ADDENDUM NO. 1

JAY COUNTY BRIDGE NO. 139 ON
SEVENTH STREET OVER SALAMONIE RIVER
JAY COUNTY, INDIANA

Revisions to Jay 139 Contract Documents

TYPICAL SECTIONS

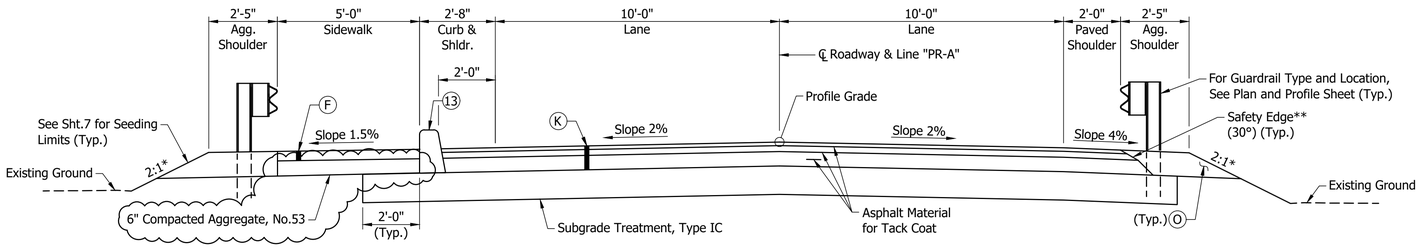
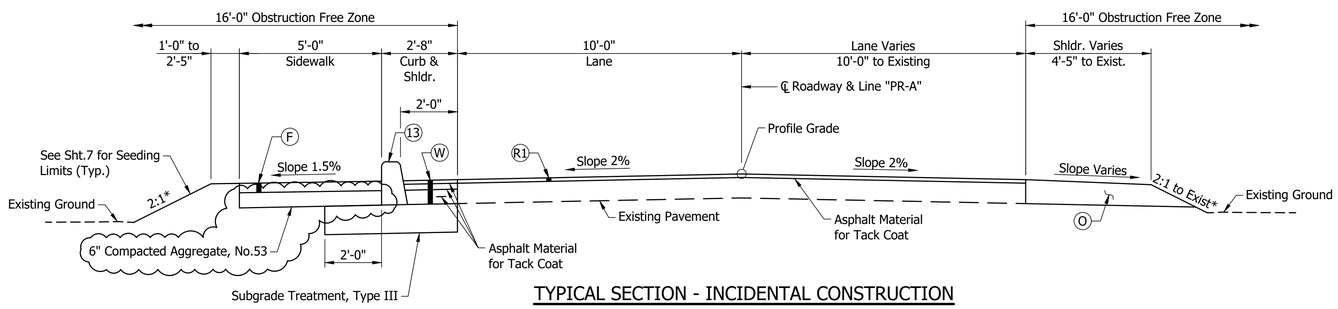
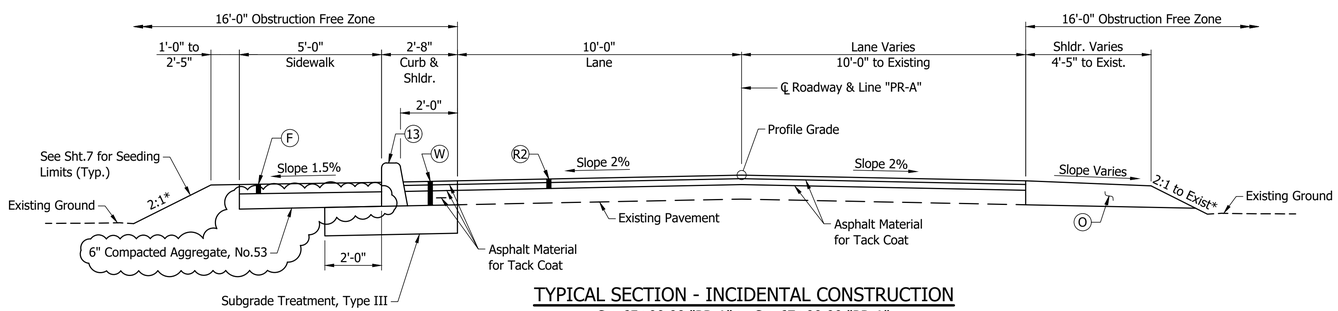
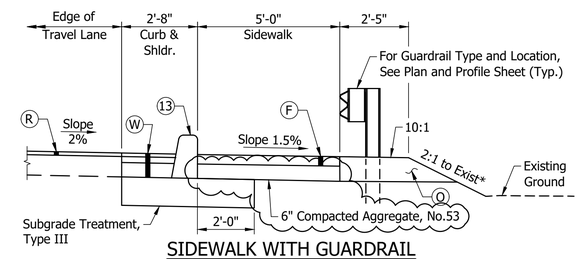
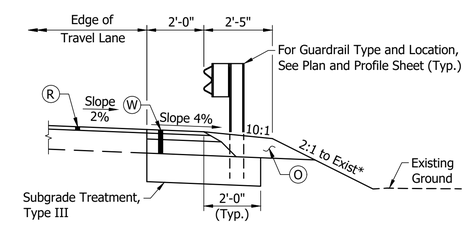
5. The FINAL TRACINGS PLAN sheets 2, 3, 10, 25, 29, 31-37 have been revised for revisions to the concrete curb over the bridge and sidewalk compacted aggregate thickness and associated earthwork quantities (see attached).

4/9/2025 Revised Sidewalk Compacted Aggregate

BRIDGE RAILING DETAIL

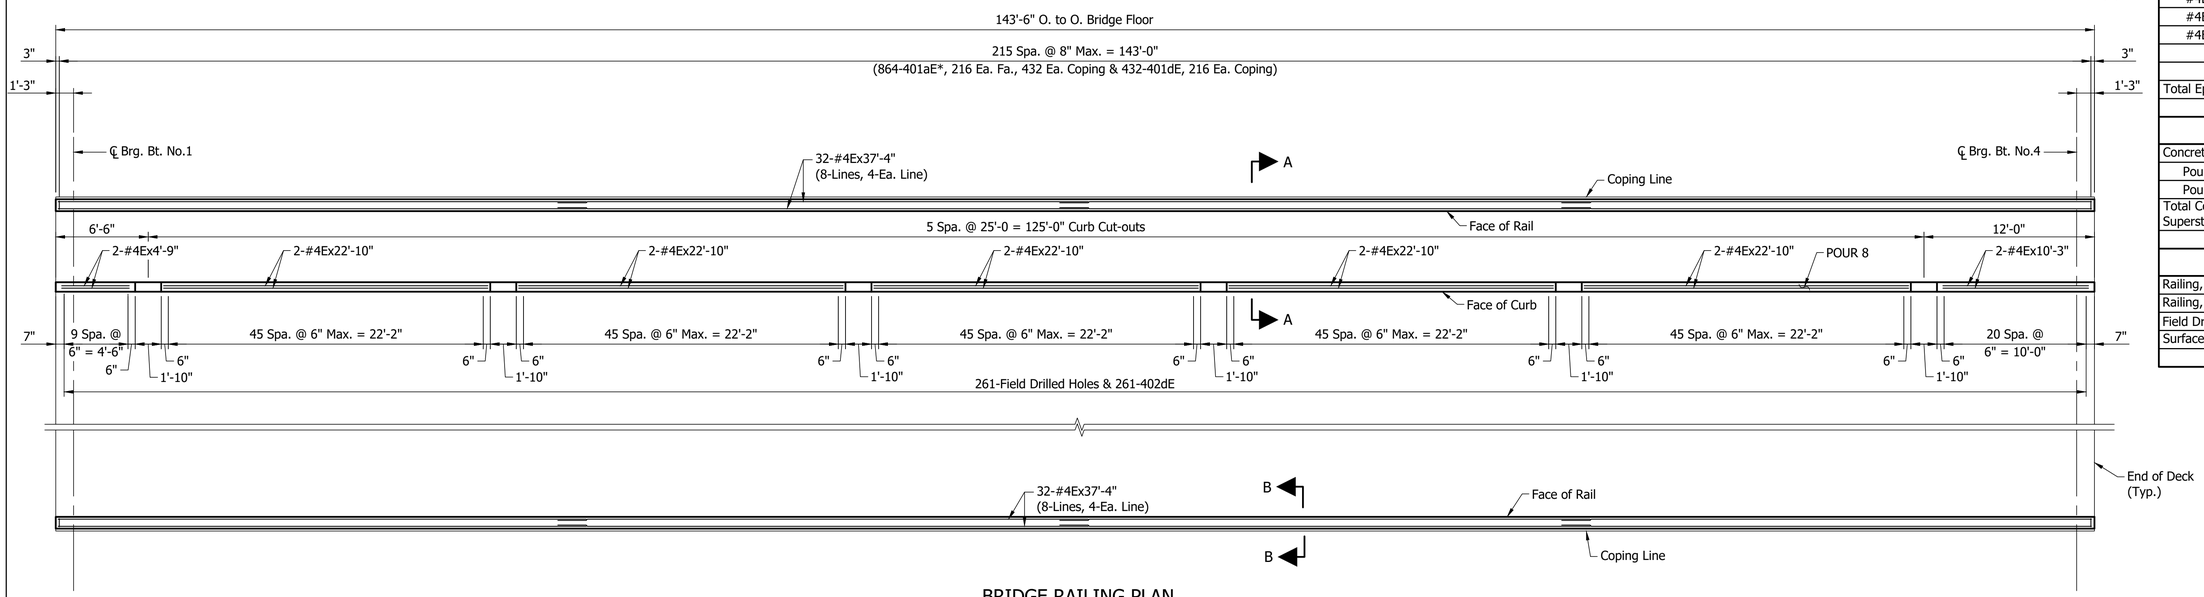
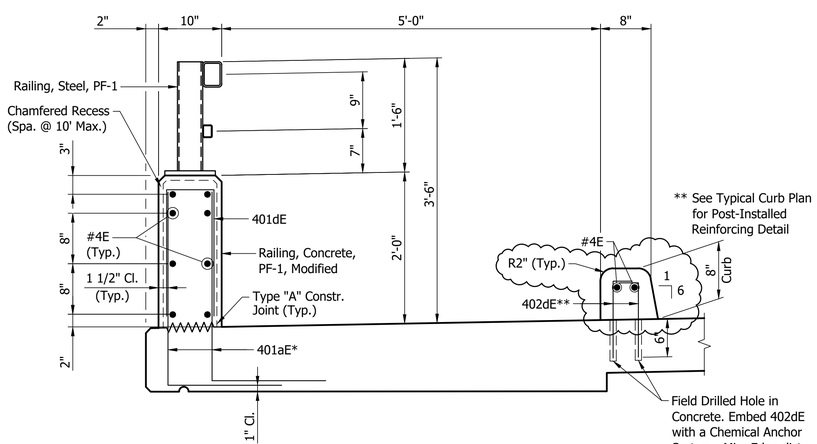
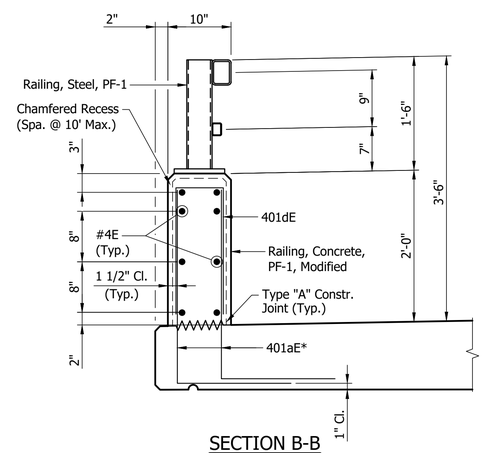
4/9/2025 Revised Curb Geometry

HORIZONTAL SCALE	BRIDGE FILE
AS NOTED	JAY 139
VERTICAL SCALE	DESIGNATION
AS NOTED	
DRAWING NO.	SHEETS
C20 of C20	29A of 37
CONTRACT	PROJECT
	091024

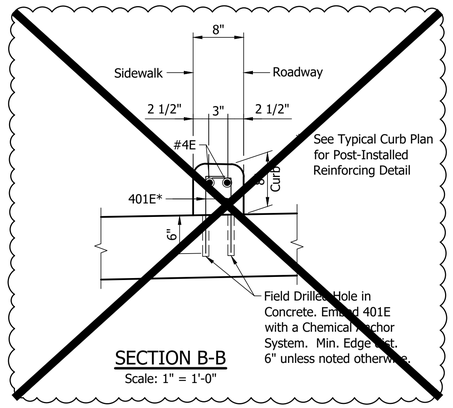
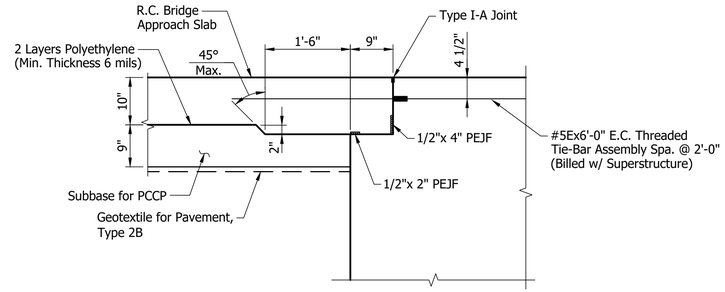
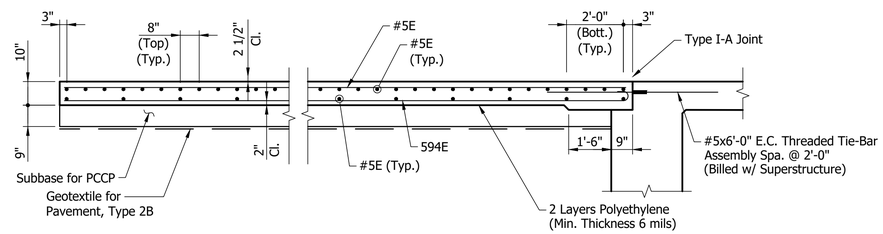
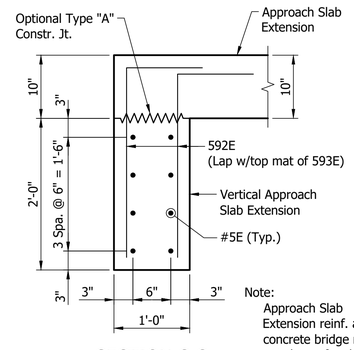
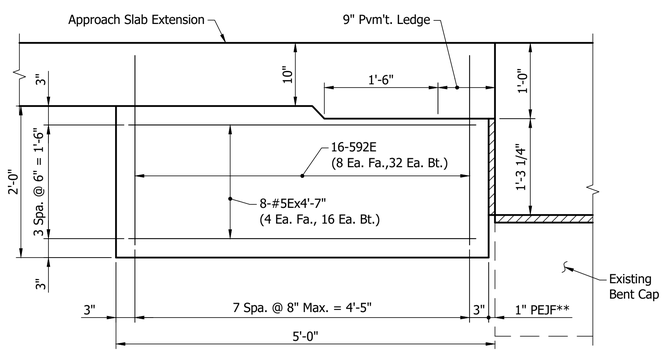
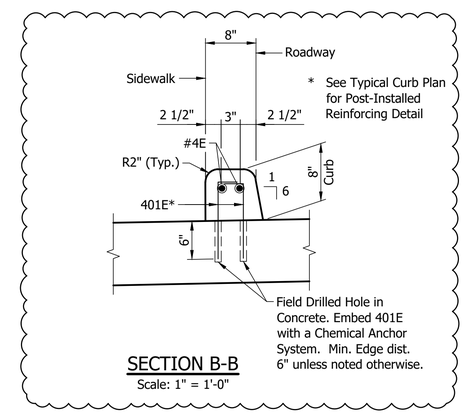
4/9/2025 Revised Curb Geometry

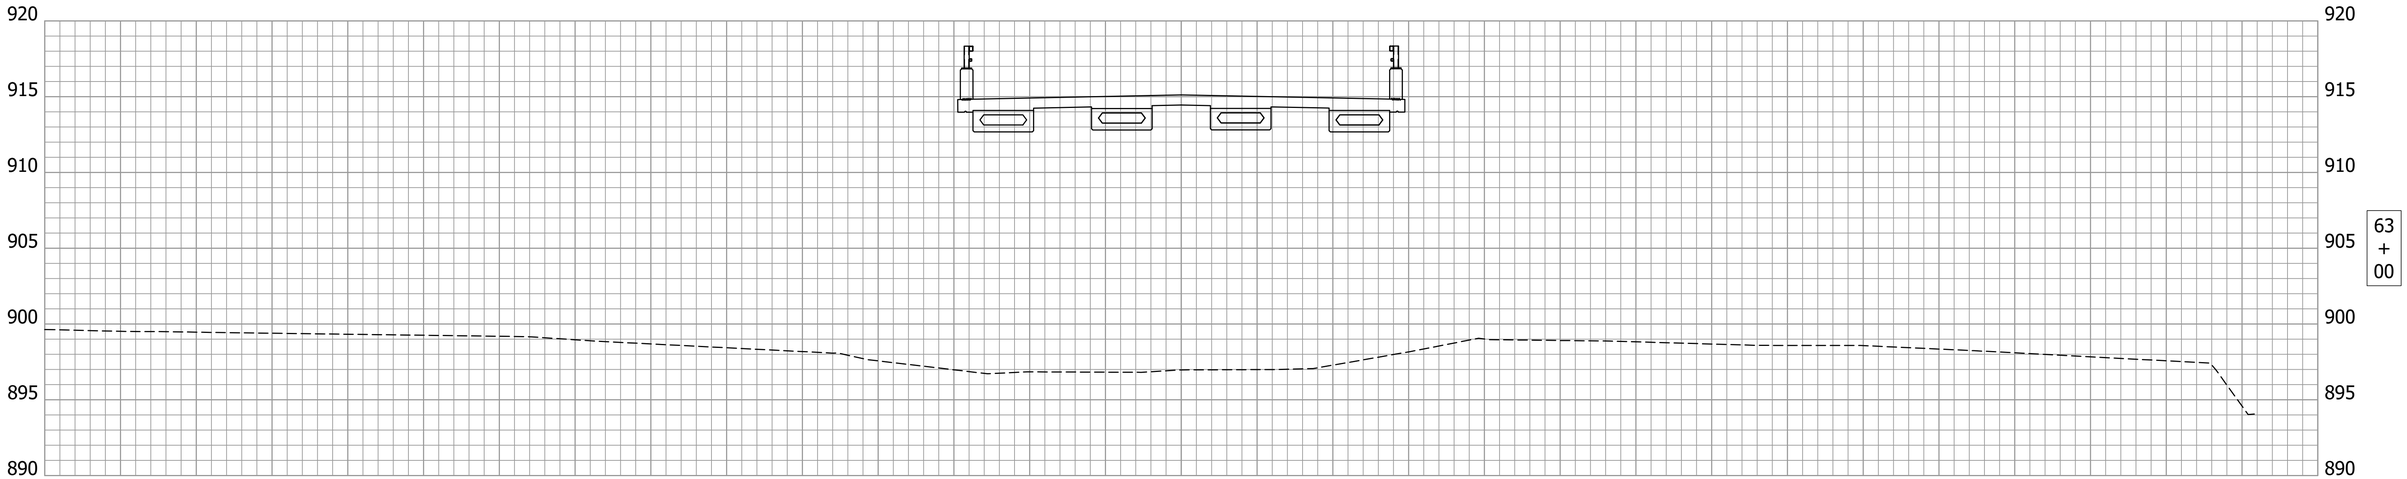
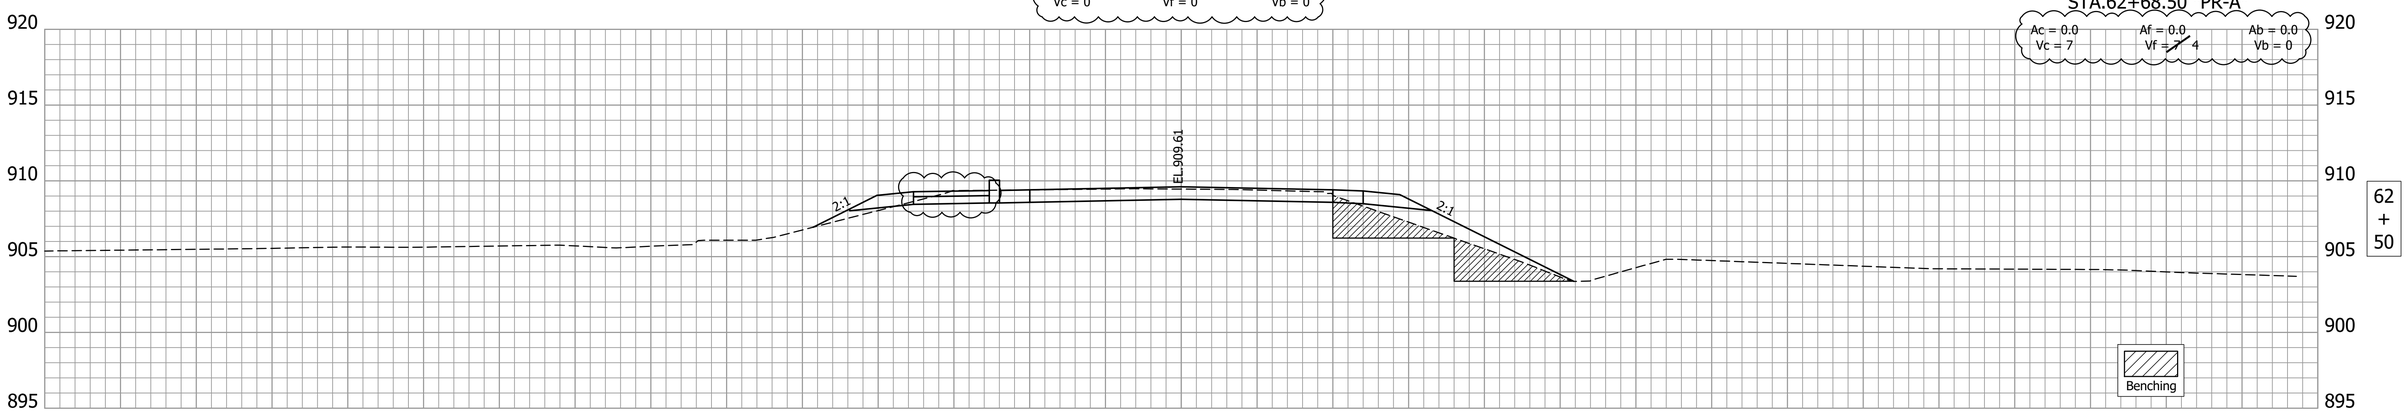
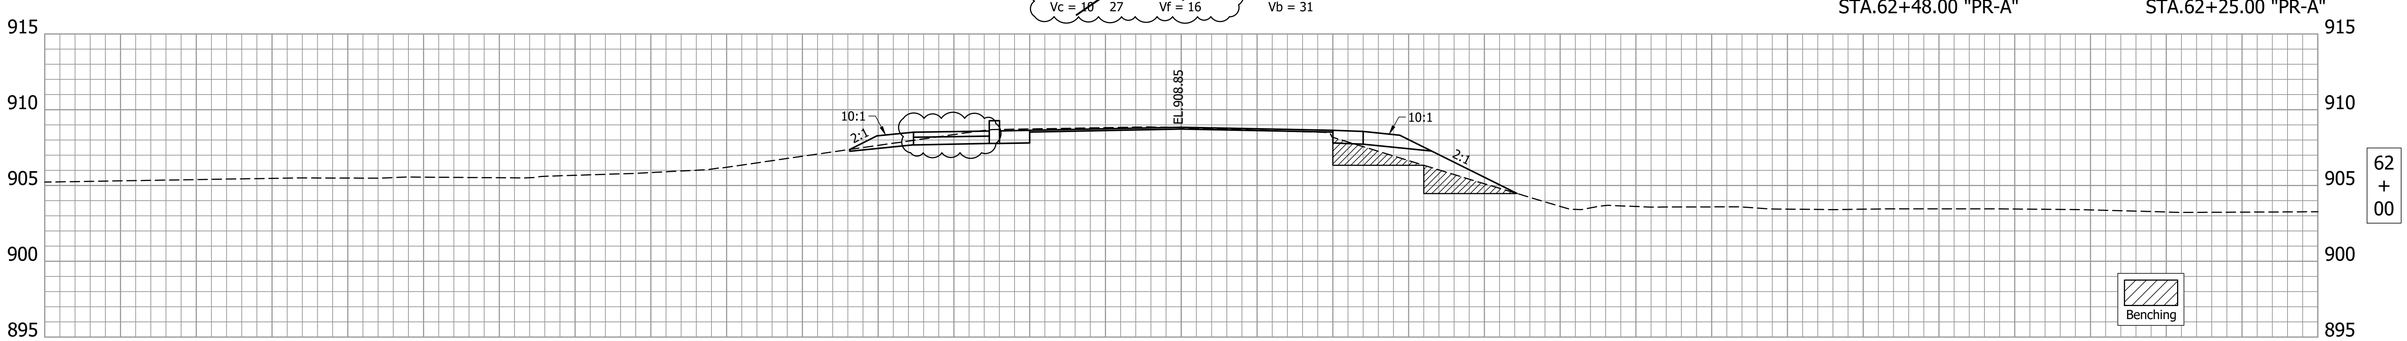
Ac = 0.0 Af = 0.0 Ab = 0.0
Vc = 7 Vf = ~~7~~ 4 Vb = 0

Ac = ~~18.4~~ 20.7 Af = ~~10.9~~ 10.7 Ab = 22.6
Vc = ~~10~~ 27 Vf = 16 Vb = 31

Ac = ~~6.5~~ 8.8 Af = 6.0 Ab = 11.3
Vc = ~~13~~ 17 Vf = 8 Vb = 10

4/9/2025 Revised Earthwork Quantities

HORIZONTAL SCALE	BRIDGE FILE
1" = 5'	JAY 139
VERTICAL SCALE	DESIGNATION
1" = 5'	
DRAWING NO.	SHEETS
	34A of 37
CONTRACT	PROJECT
	091024

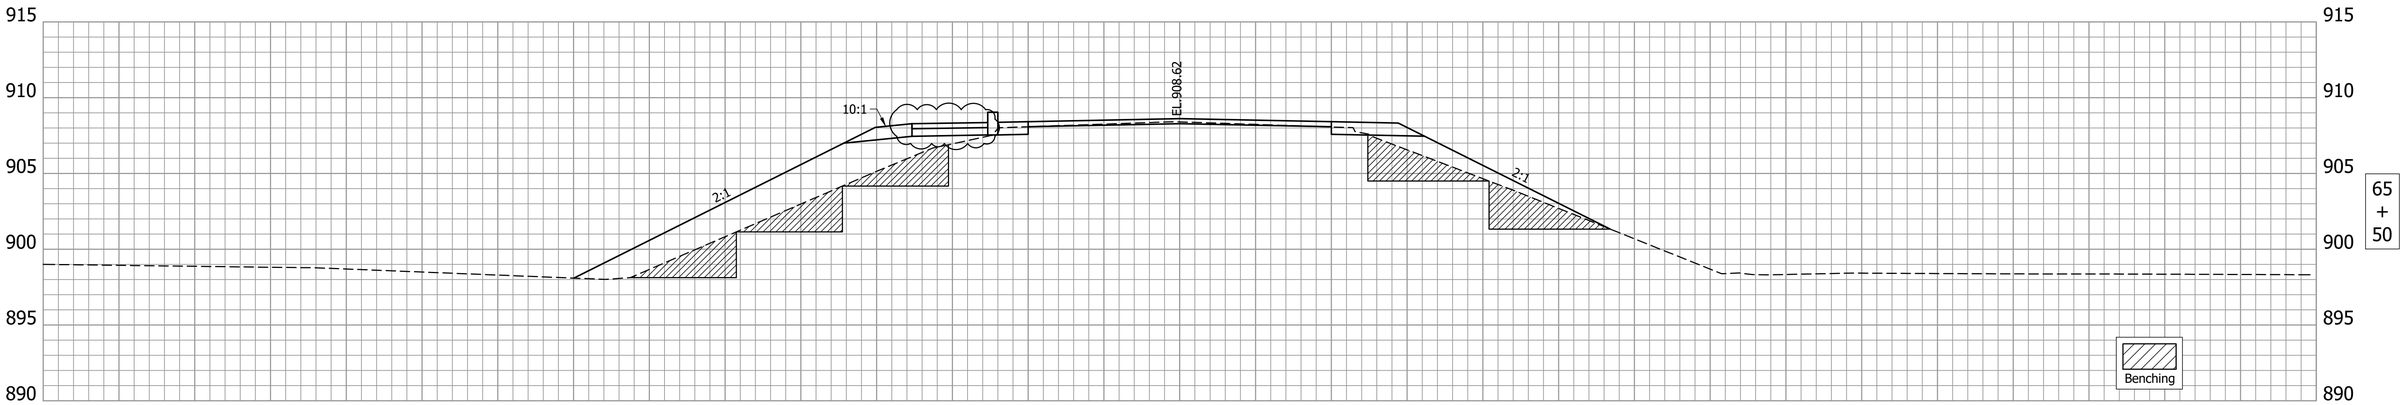
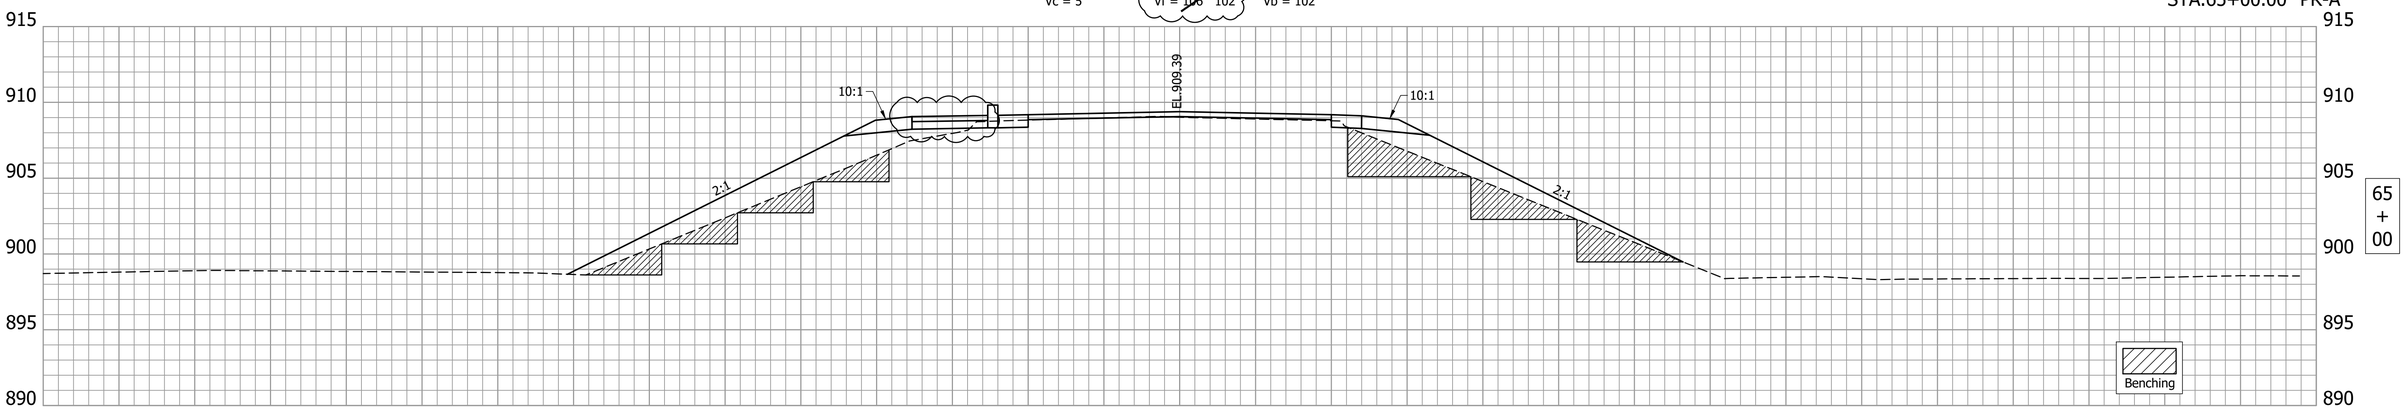
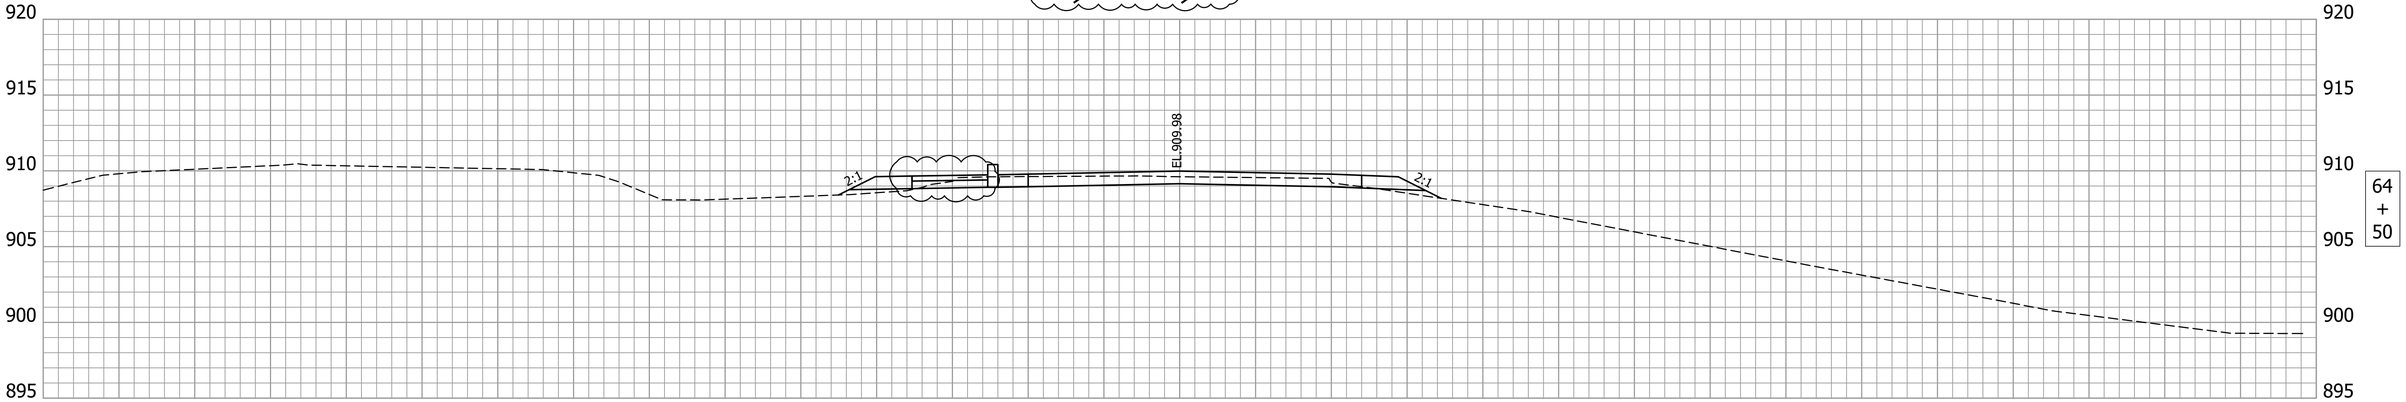
Af = 61.3 58.9
Vf = 106 102

Ac = 1.6 2.0
Vc = 14 16

Af = 52.7 51.0
Vf = 51 49

Ac = 13.5 15.2
Vc = 10 11

Af = 2.6 1.8
Vf = 2 1

4/9/2025 Revised Earthwork Quantities
